CITY COUNCIL REPORT

Hazel & Azure – Canal Improvements 37-DR-2021#2

1. Pursuant to the requirements of Ordinance No. 3909 (65-ZN-1992#7), City Council review and approval of the Development Review Board application for the hardscape and landscape plans for the canal bank improvements associated with the Hazel & Azure mixed-use development (37-DR-2021).

LANDSCAPE PLAN
L-100

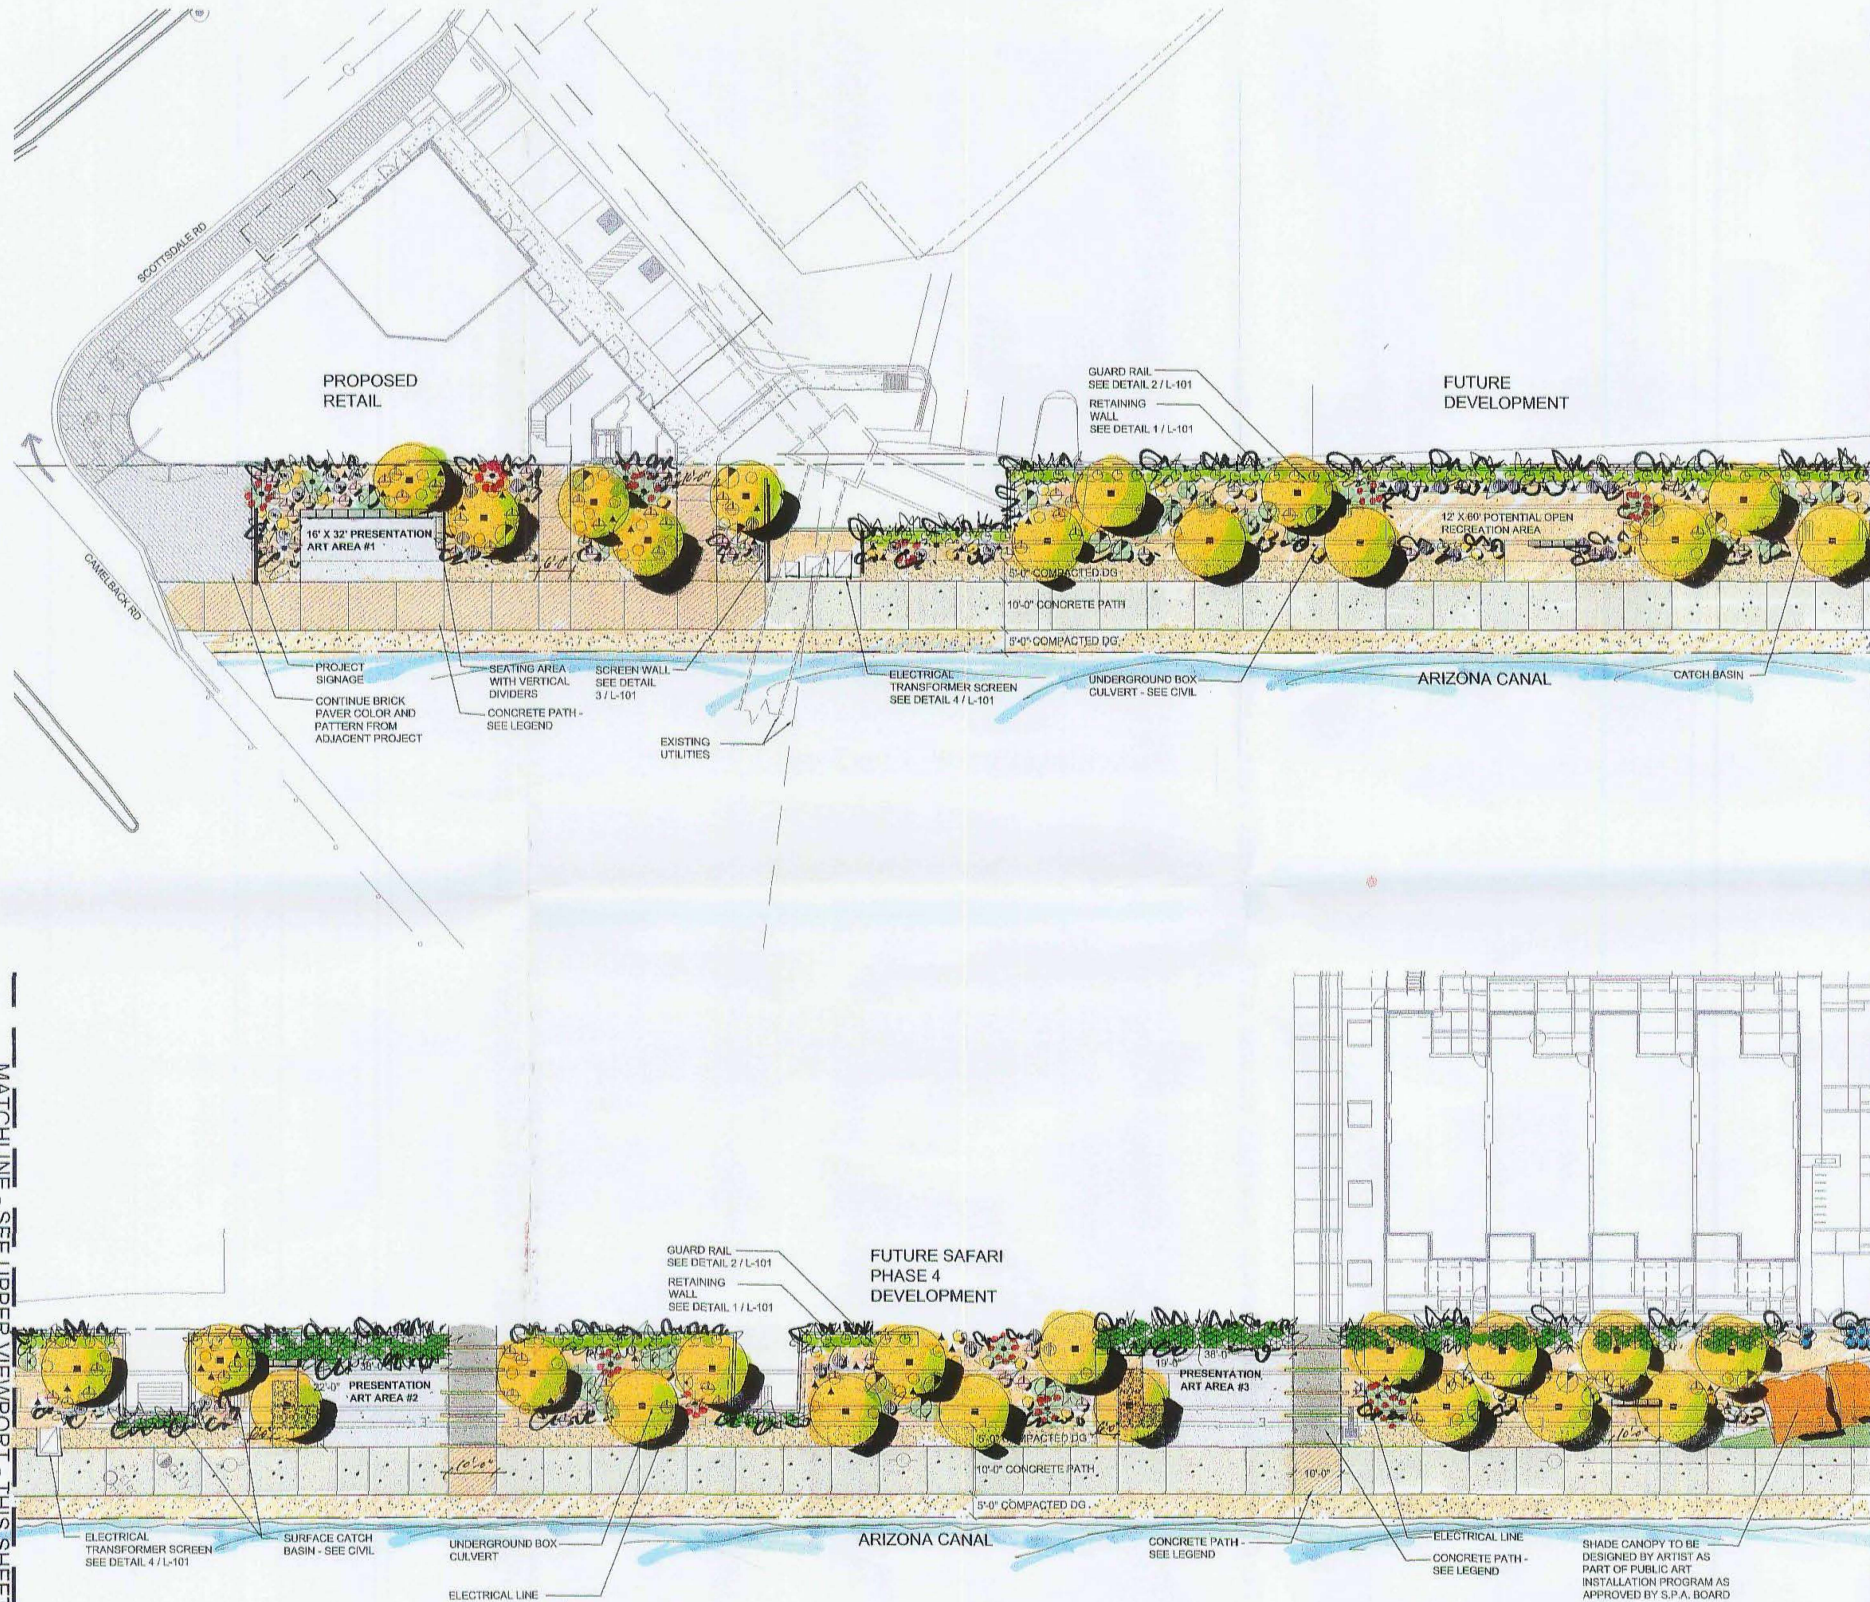
As discussed, Hazel and Azures current canal bank proposal is unacceptable as it does not meet their stipulation from 2007 (see attached). Please note that the approved plan already considered the box culvert inlet condition and proposed a short retaining wall along the outside edge of the canal ROW. Even if FCD does not allow a small retaining wall in their ROW, there's plenty of room to widen the top of bank and simply slope the outer edge to catch grade, as depicted on the image below. Another option is to raise the box culvert inlet. Have either of these options been explored? I understand that they may have run into resistance from SRP/FCD but defaulting to leaving this segment narrow in lieu of exploring all options is not right or in the best interest of the City, the community &/or the surrounding properties. Nobody bothered to reach out to us. As discussed, it is critical to provide the full width improvements, not only from an esthetic value at this key location, but also to create enough space for the eventual bridge to land that will be extended across the canal from our proposed Edition hotel to the east.

In summary, there are solutions that do not appear to have been considered. I suggest a stipulation that requires them to either comply with the full-width requirements, or suggest you continue the case to allow time for proper coordination between vested parties. Unfortunately, the first we heard of their intent to do something other than what was approved, is from your email of yesterday.
